# **Wollongong Local Planning Panel Assessment Report** | 3 November 2020

WLPP No.	Item 1
DA No.	DA-2020/572
Proposal	Residential - multi dwelling housing - demolition of existing warehouse storage facility and construction of 12 x two storey dwellings.
Property	481-485 Princes Highway, WOONONA NSW 2517 Lot 1 DP 86796
Applicant	MMJ Wollongong
Responsible Team	Development Assessment and Certification – City Wide Planning Team (SG)

Figure 12: Proposed setbacks of the development relative to the neighbouring sites (\*Source: TJA)

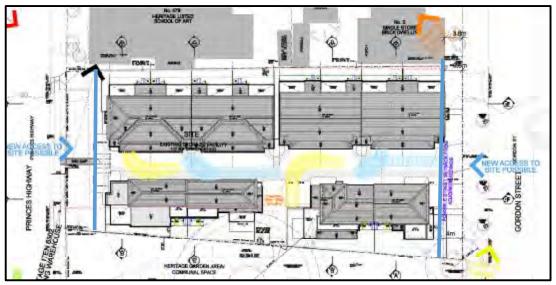
• Clause 5.3.2.1 - A 6m setback requirements applies from the front property boundary to the front façade of the building.

The setback to Princes Highway is in excess of 6m to respect adjacent heritage items. The setback to Gordon Street is less than 6m but is consistent with the existing residential setback.

- The encroachments are for a small amount of building line to the front setback, which will still maintain an appropriate setback to the adjoining neighbour. The articulation on this elevation means that the encroachment to these edges will not be overpowered by built form, and it is clear that the proposed variation will not compromise the intent "to reinforce the existing character of the street by acknowledging building setbacks and promotes compatibility in front setbacks to provide for unity in the building line".
- The front setbacks of the proposed development are still all of an appropriate distance that will
  maintain good lines of sight throughout the site's boundaries and, the tiered nature of built form
  across the site means that the edges of the development will still enable good surveillance from
  the streetscape.
